**AGENDA**  
**CITY OF LAKE WORTH BEACH**  
**SPECIAL CITY COMMISSION MEETING - QUASI JUDICIAL HEARINGS**  
**BY TELECONFERENCE**  
**TUESDAY, JUNE 30, 2020 - 6:00 PM**

# EXECUTIVE BRIEF SPECIAL MEETING

Ordinance No. 2020-08 – second reading – approve the establishment of a mixed use urban planned development for The Bohemian

DATE: May 20, 2020  
TO: Members of the Planning and Zoning Board  
FROM: Alexis Rosenberg, Senior Community Planner and Andrew Meyer, Senior Community Planner  
THRU: William Waters, AIA, NCARB, LEED, AP BD+C, ID, SEED, Director for Community Sustainability  
MEETING: May 27, 2020

**SHEET NUMBER:**  
**A-2.0**

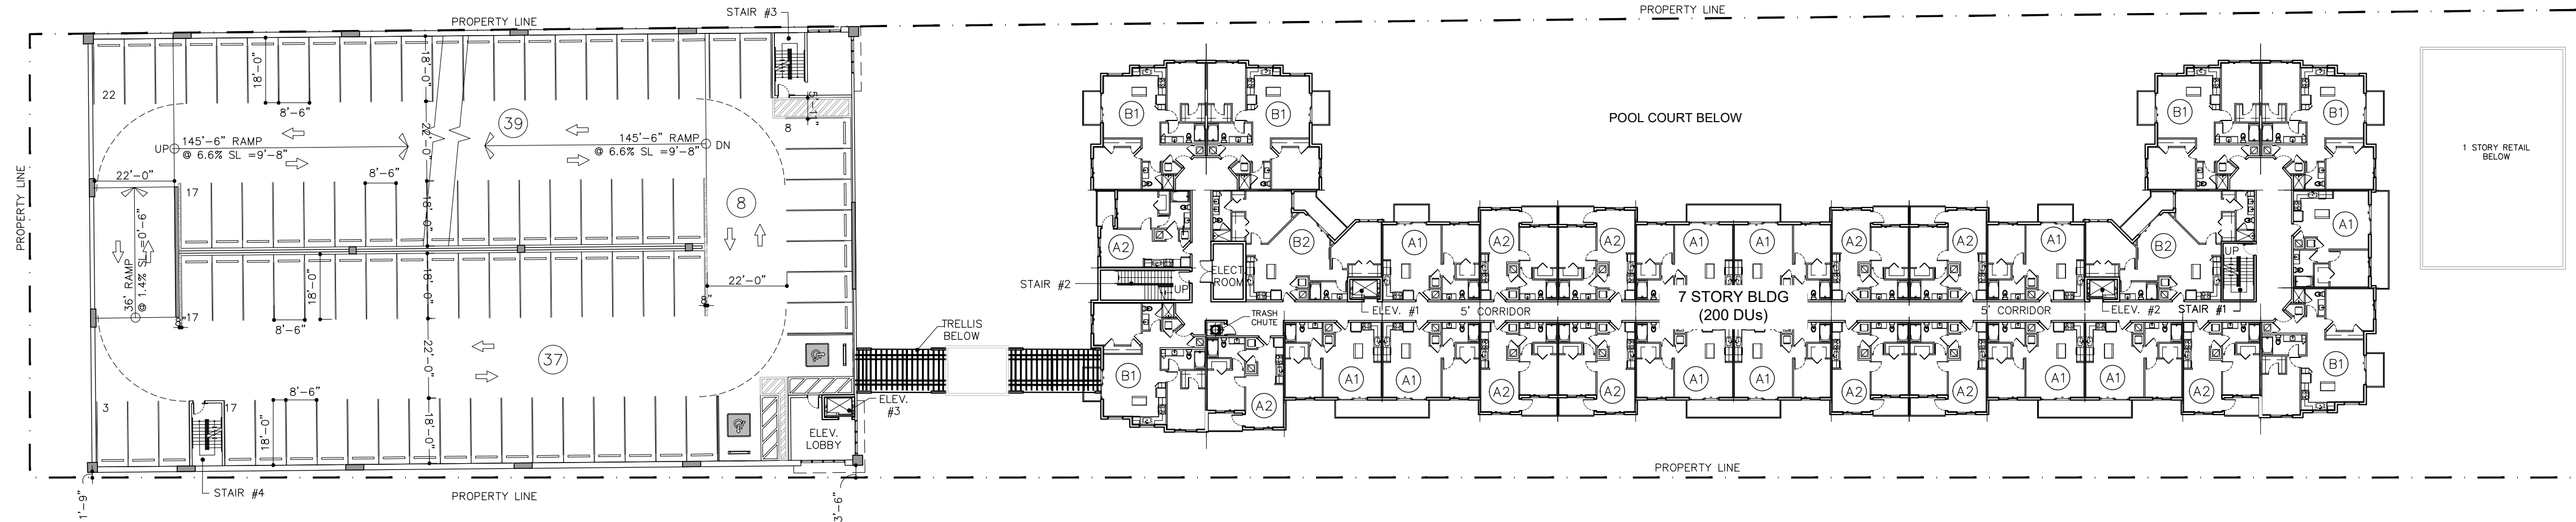
- c. Relabel the "pool court" on page A-2.0 to "open lawn," as that is the correct label for this area per page SP-1.
2. The proposed density for this project of 98.2 dwelling units per acre will not be effective and cannot be constructed until the transmittal to DEO for review and the adoption by the City Commission of the proposed concurrent amendment to the City's Comprehensive Plan to raise the base density in the TOD-E zoning district from a maximum of 50 dwelling units per acre to a maximum of 60 dwelling units per acre.

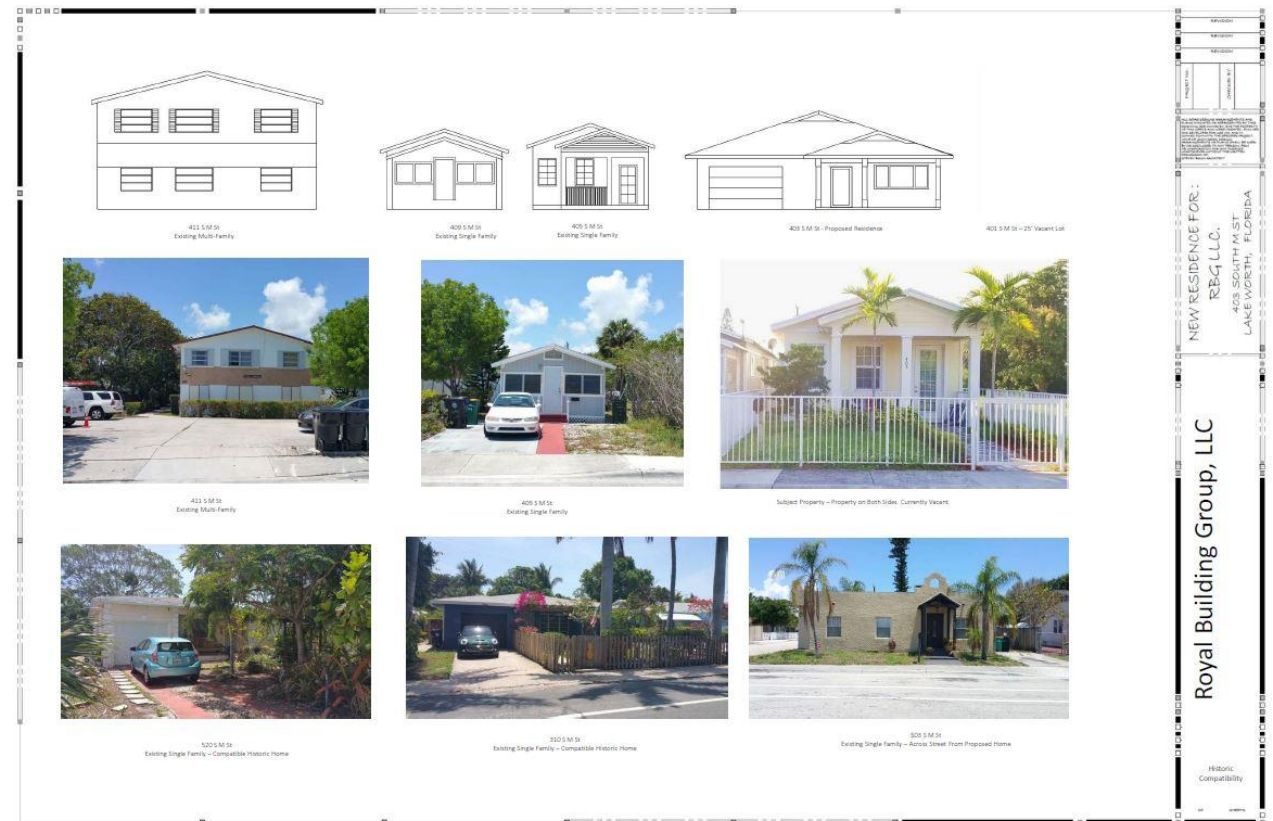
7. Compatibly sized windows shall be added to the north and south facades to avoid the long expanses of blank façade.

## **Staff Report Conditions of Approval**

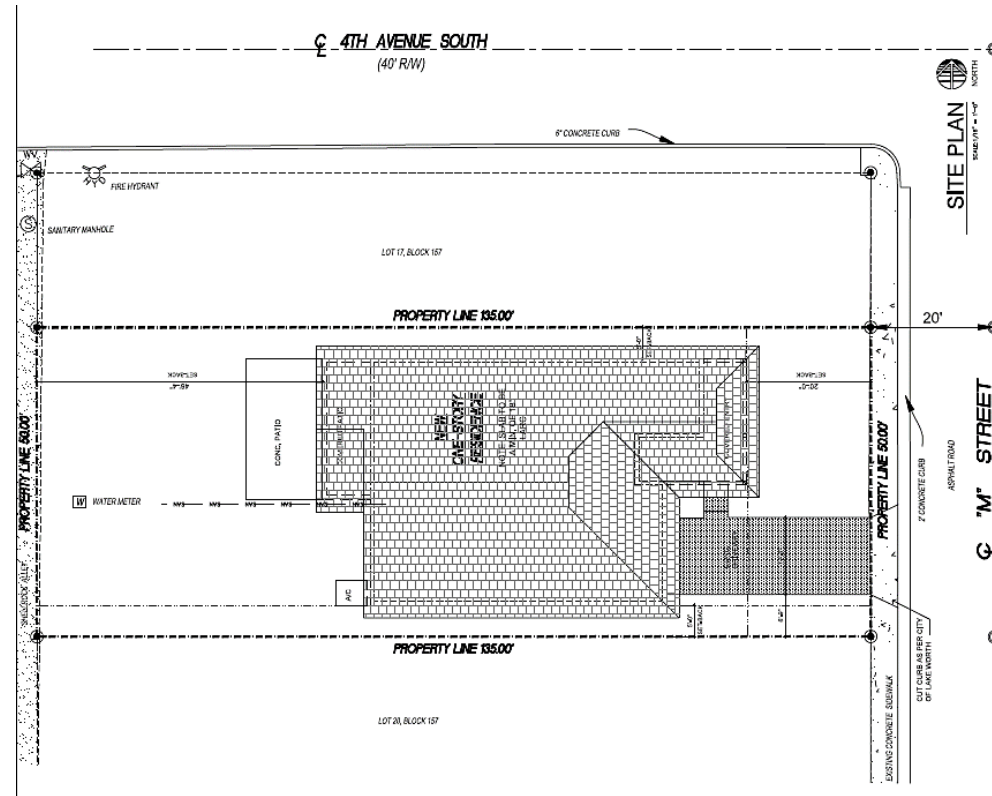
7. The front porch window and column configuration shall be changed to be symmetrical with two (2) vertically oriented single-hung windows with columns spaced evenly across.

# Board Conditions of Approval

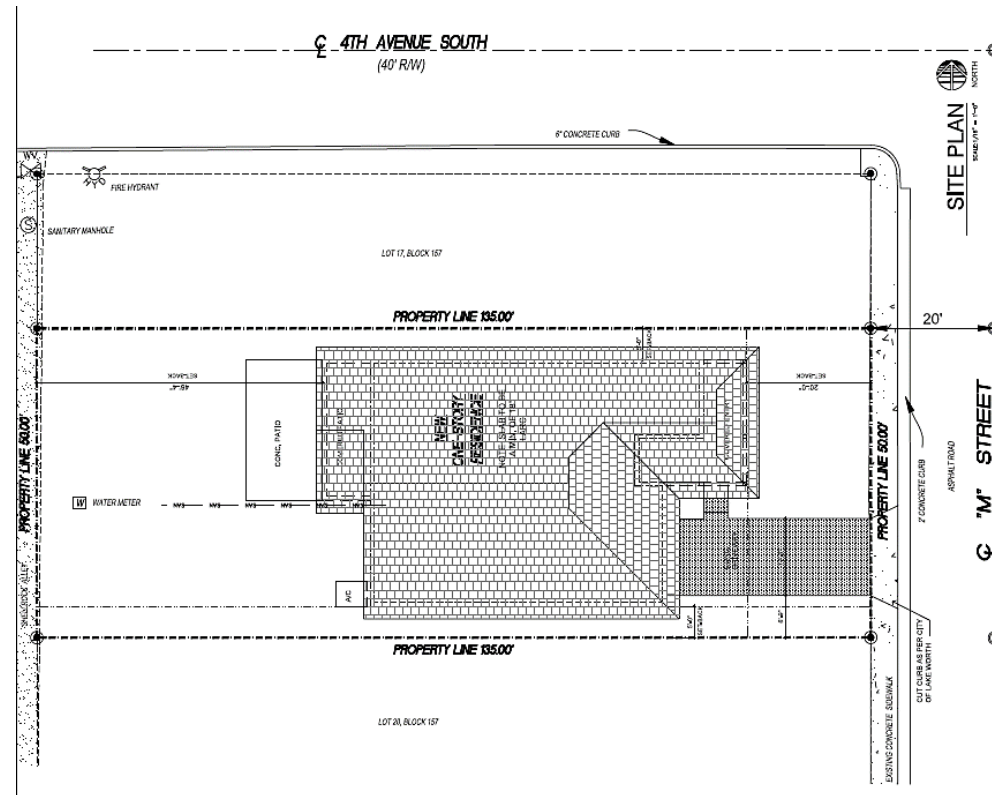
8. The driveway shall be reduced in size so that a walkway connecting the front door with the sidewalk can be added without going over the front yard impermeable surface provision.

- The driveway shall be reduced from 12 feet to 10 feet wide with flares at the sidewalk.

Figure 2 – Plan view of proposed front porch.

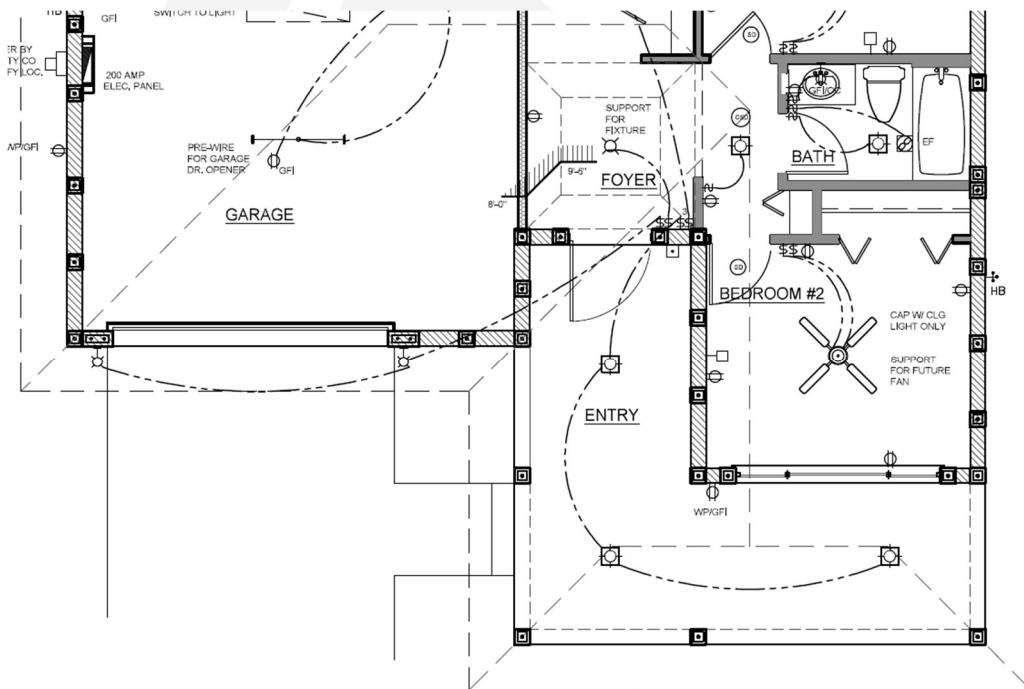
The drawing above (Figure 1) shows the proposed front elevation. The design of the porch and columns as well as the window were arrived at through careful consideration by the architect and applicant. Columns were placed at the desired locations along with the horizontal window with high sill to allow for furniture to be installed on the porch. A floor plan of the porch and column layout is provided below (Figure 2).

This decision was arbitrary, if the board had reviewed the Historic Preservation Design Guidelines, they would have seen examples of both horizontally aligned windows and asymmetrical columns. In fact, the below drawing (Figure 3) is from Page 57 of the Historic Preservation Design Guidelines and is used to illustrate the style description for Masonry Vernacular construction. This drawing features a masonry building with both asymmetric columns and a horizontally oriented window.
